## HISTORIC AND DESIGN REVIEW COMMISSION

**2017-497**

622 CEDAR ST

Construction of a rear addition and rear porch

EXISTING & PROPOSED  
SITE/ROOF PLAN

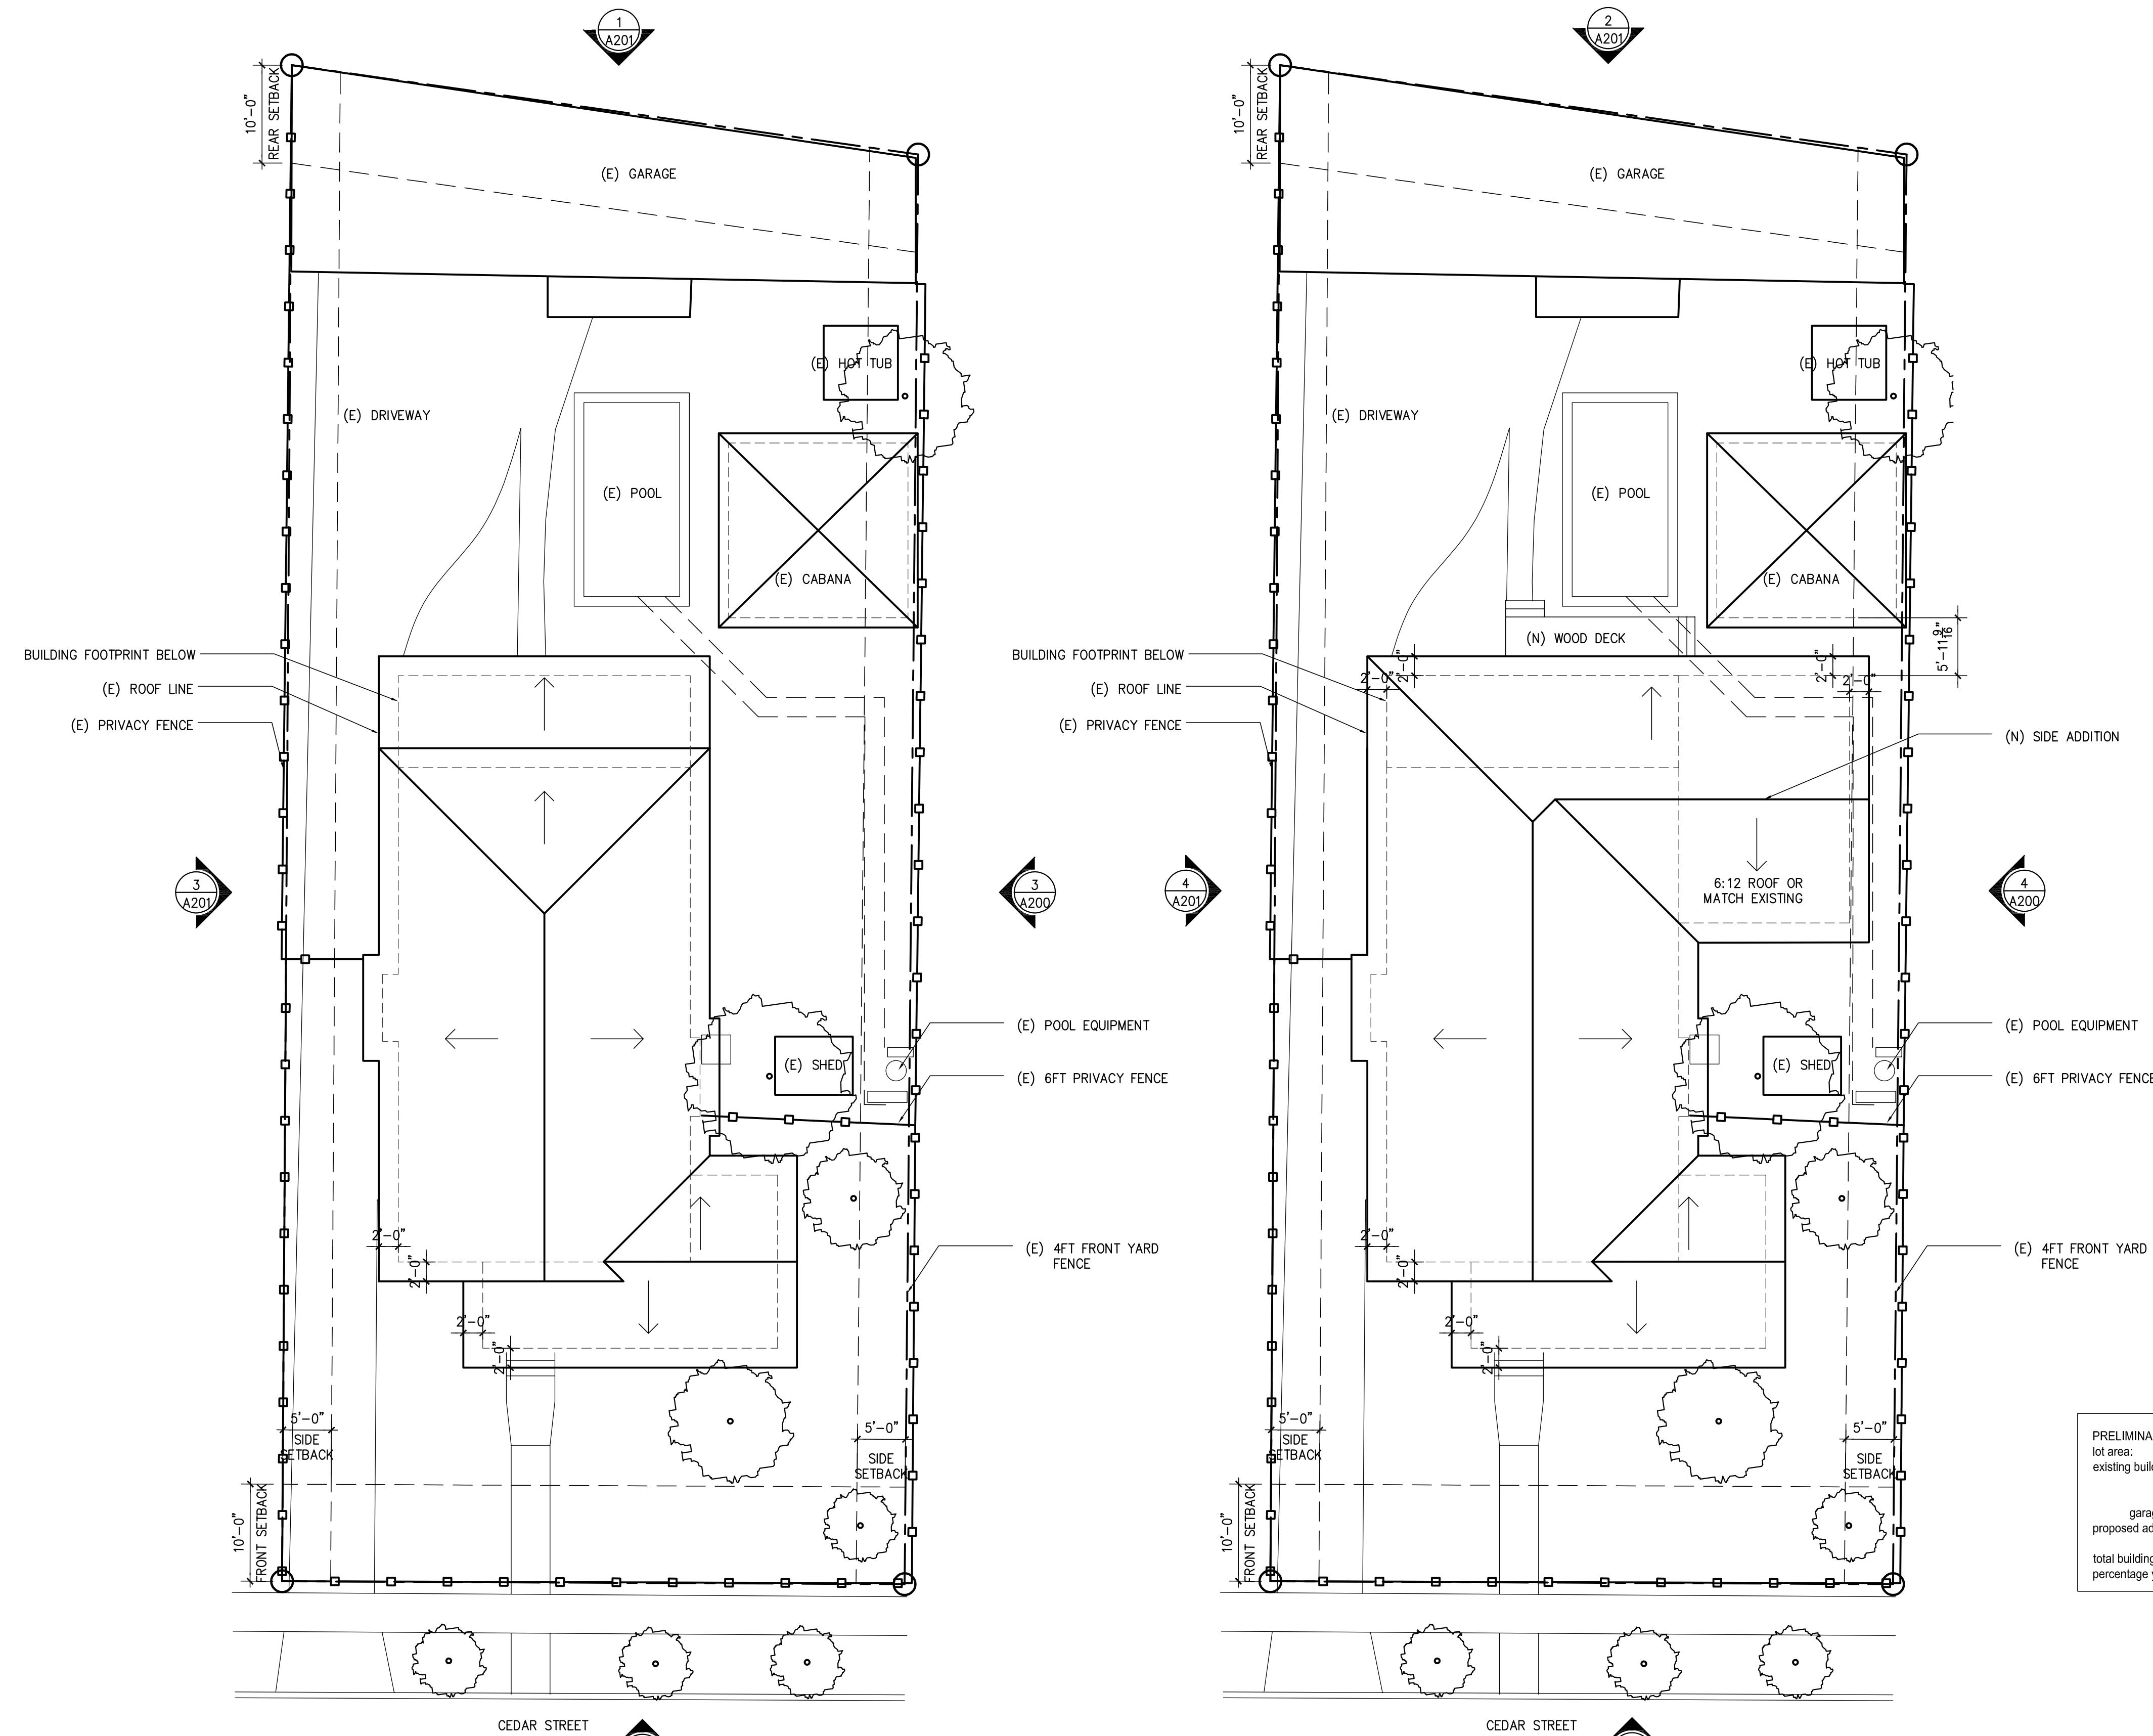
- e. SCALE, MASS & FORM – Regarding scale, mass and form, the applicant has proposed for the addition to feature a roof height that is subordinate to that of the primary historic structure and generally a footprint that is appropriate for the footprint of the primary historic structure.

#### PROPOSED EXTERIOR ELEVATIONS

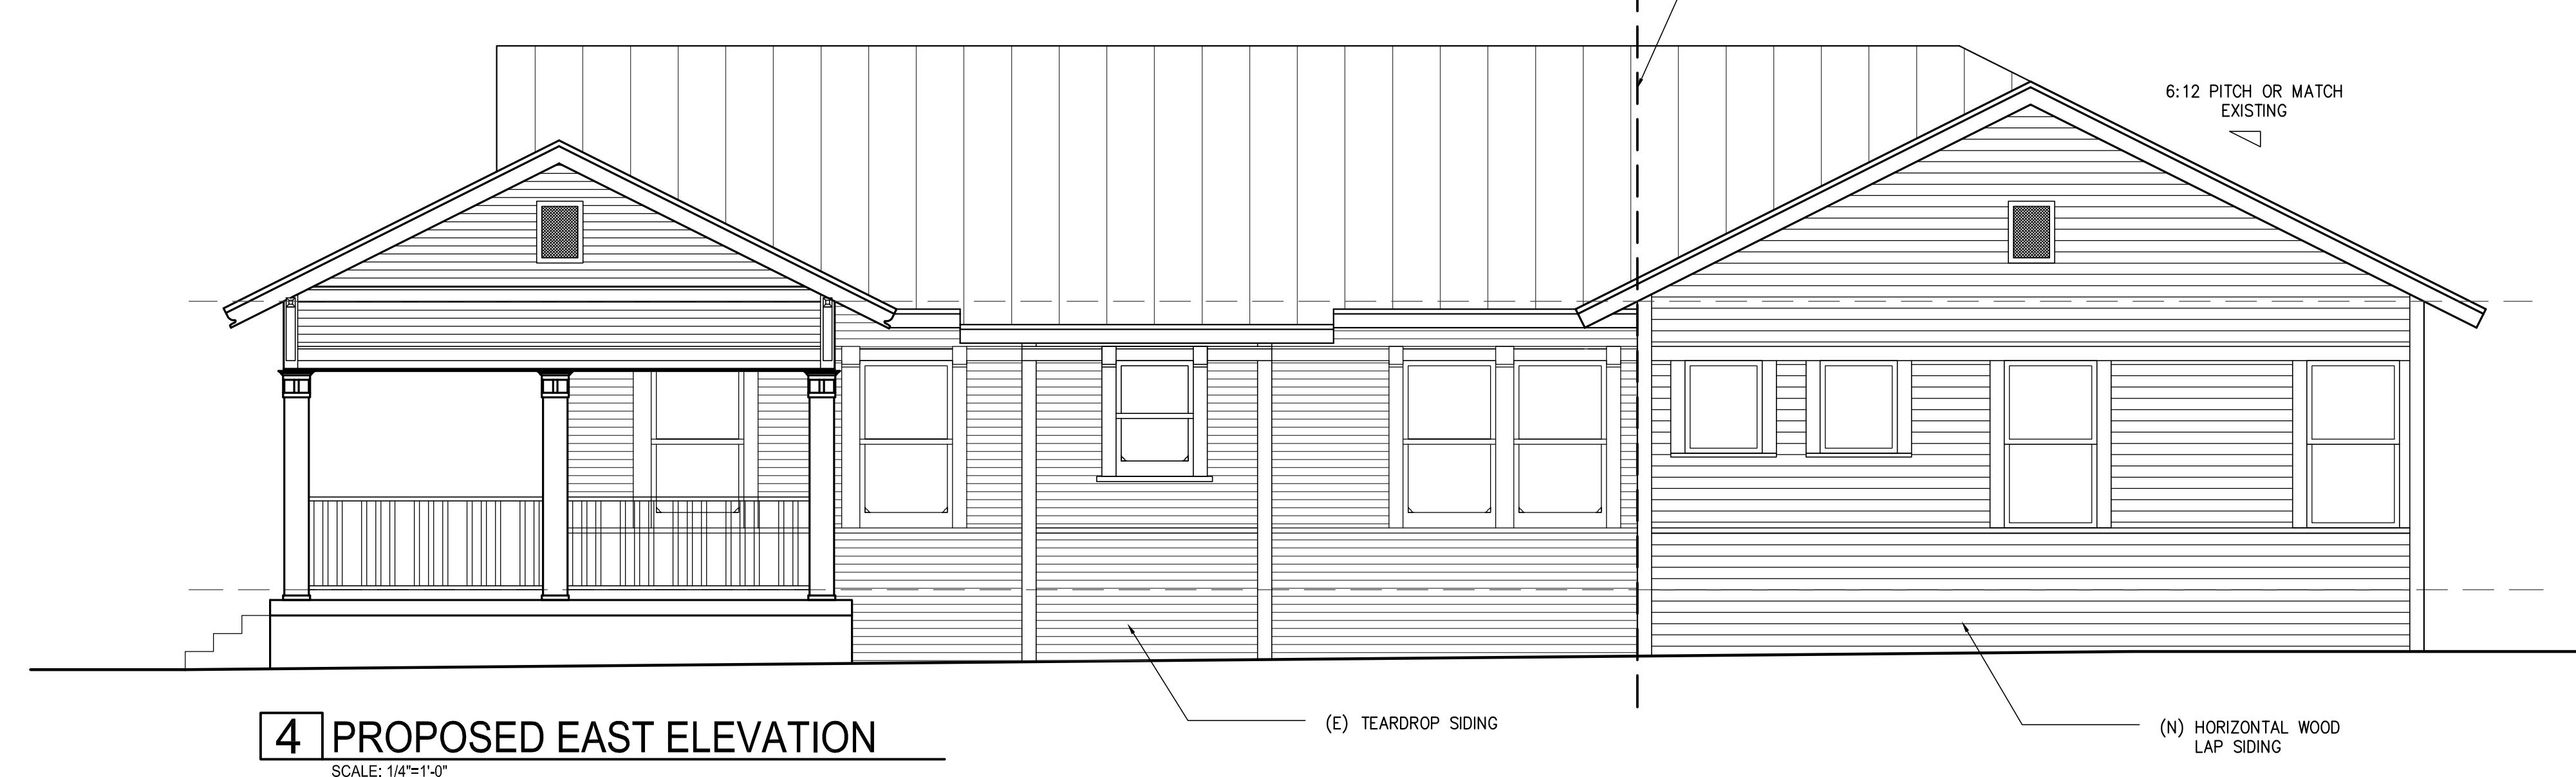
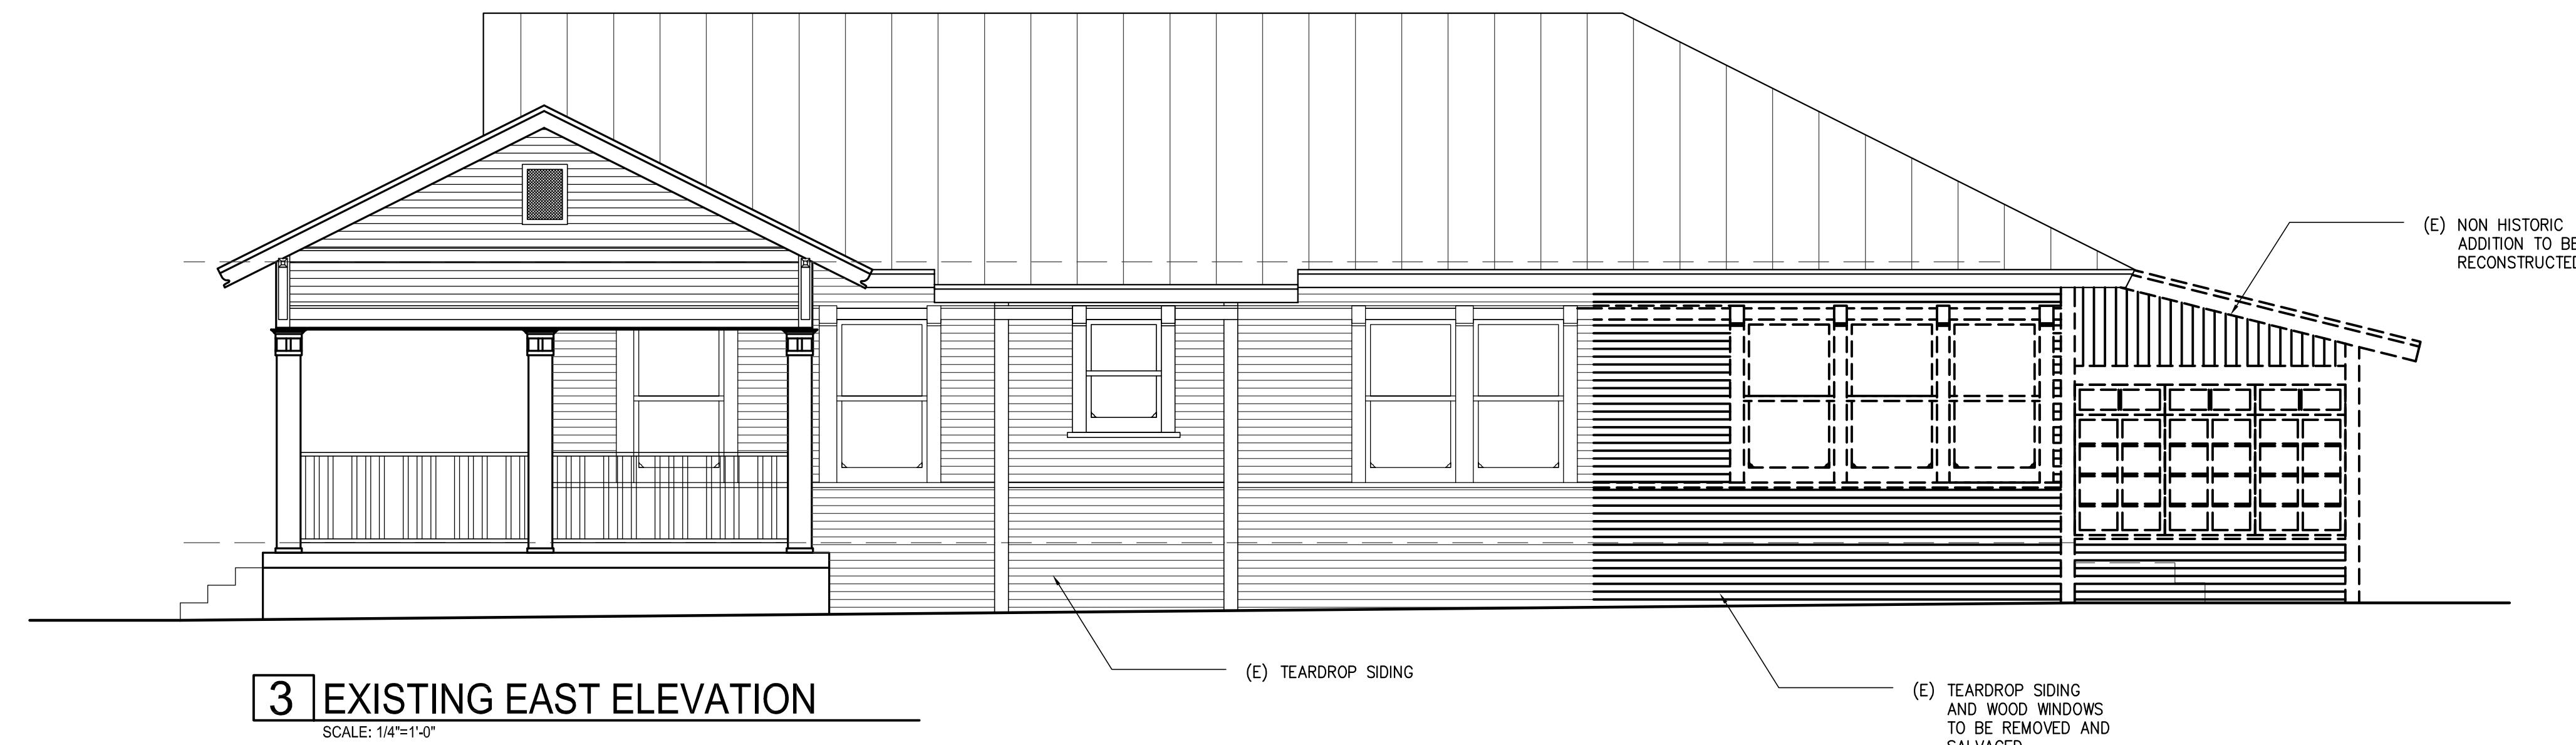
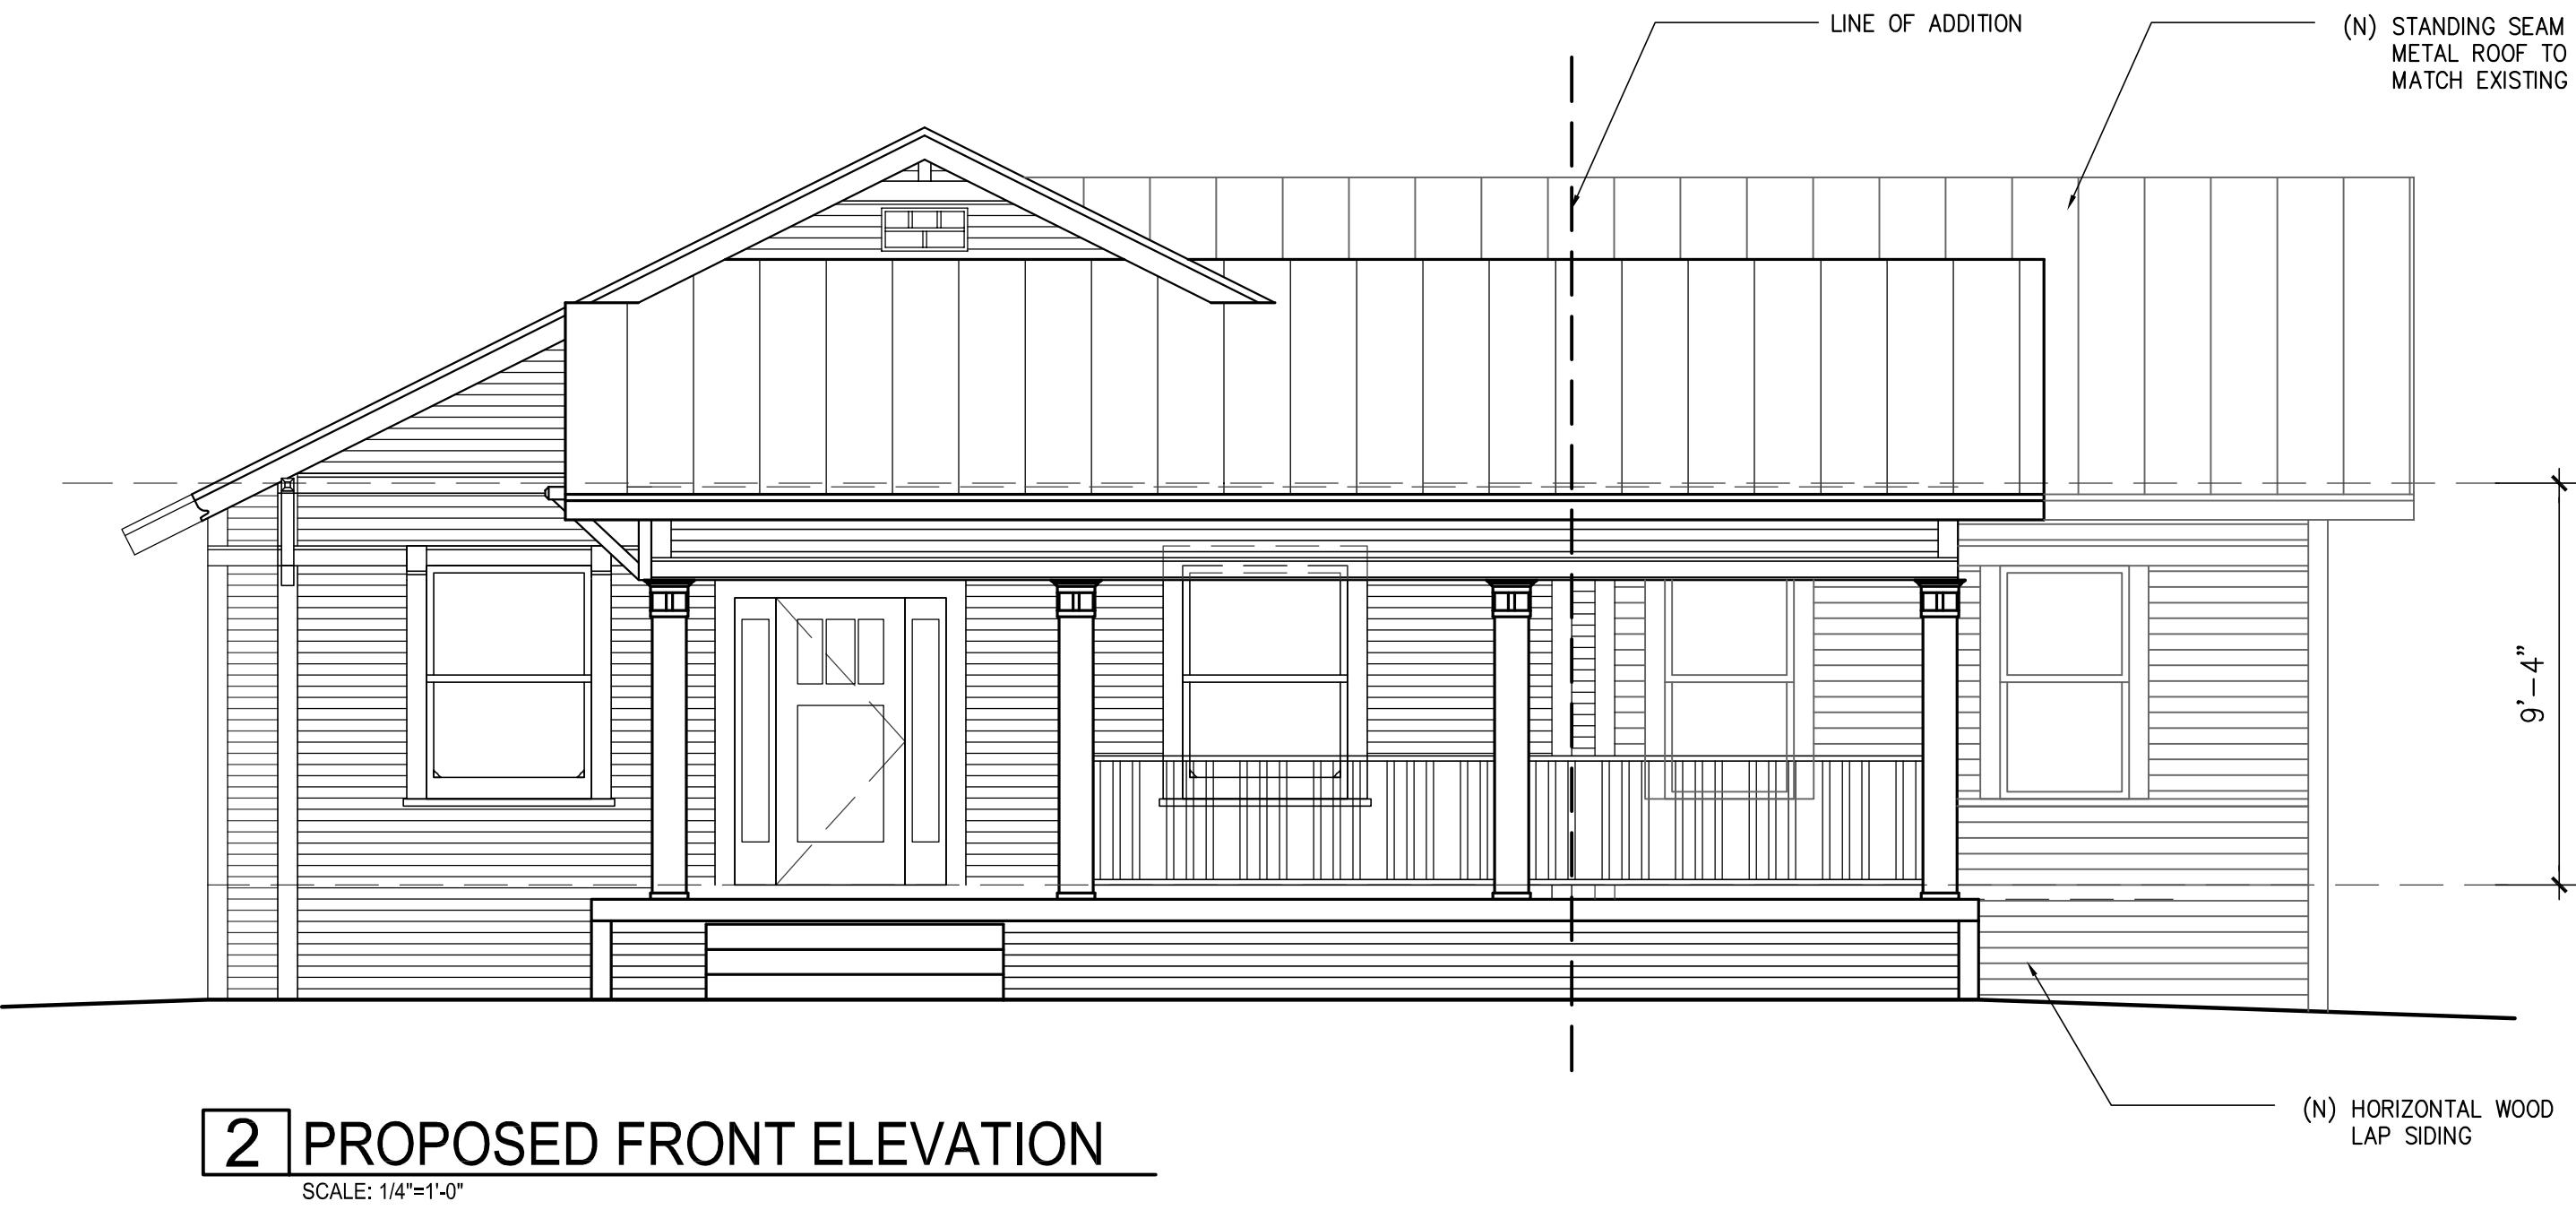
- iii. That the proposed fixed windows on the east elevation be sash windows.
- iv. That the standing seam metal roof feature panels that are 18 to 21 inches wide, seams that are 1 to 2 inches tall, a crimped ridge seam and a standard galvalume finish.
